Clarification on PTP Timestamping in the presence of Alignment Markers

Steve Gorshe, Richard Tse, Winston Mok

IEEE 802.3 plenary meeting, July 2018

Figure 119–2—Functional block diagram

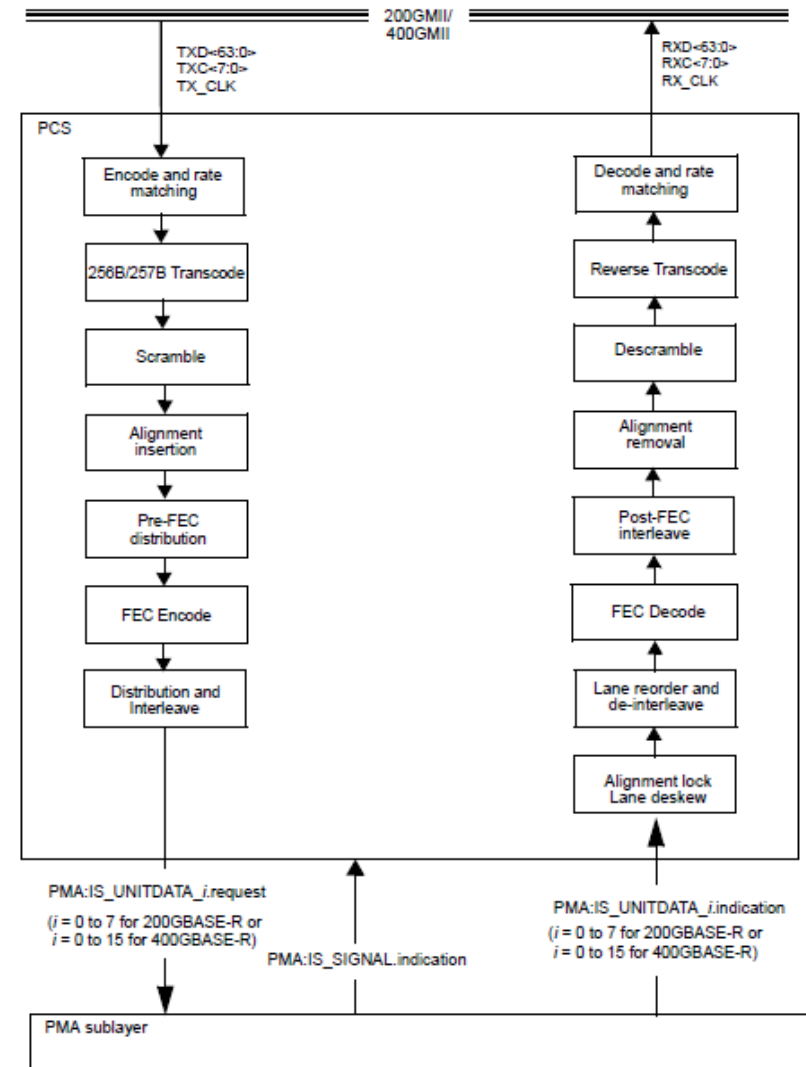
- Newer PHYs (200GBASE-R PHY is shown) are more complicated with respect to timestamping
 - Timestamp events are captured at the xMII
 - AM insertion/removal occurs between the xMII and MDI
 - The data shift resulting from AM insertion/removal creates new considerations for accurate timestamp transmission
 - There are different allowable methods for creating the bandwidth needed for AM insertion

- Figure 119-2 (see slide 3) shows a Tx functional flow of the gRS (where timestamps are inserted) followed by rate matching followed by AM insertion
 - Accommodating AM insertion is one of the potential reasons for rate matching
 - Rate matching is typically performed by Idle insertion/removal
- Strict adherence to the functional flow of Figure 119-2 implies that the timestamp event captured at the xMII will be shifted by the AM and Idle insertion/removal process, thus creating an inaccuracy for which (unlike FEC) there is no guarantee that the Rx processes will cancel it out in the same location of the received bit stream
- 802.3 has a long established principle of recognizing implementations as being compliant as long as the device output bit stream is the same as if the process described in the standard had been applied
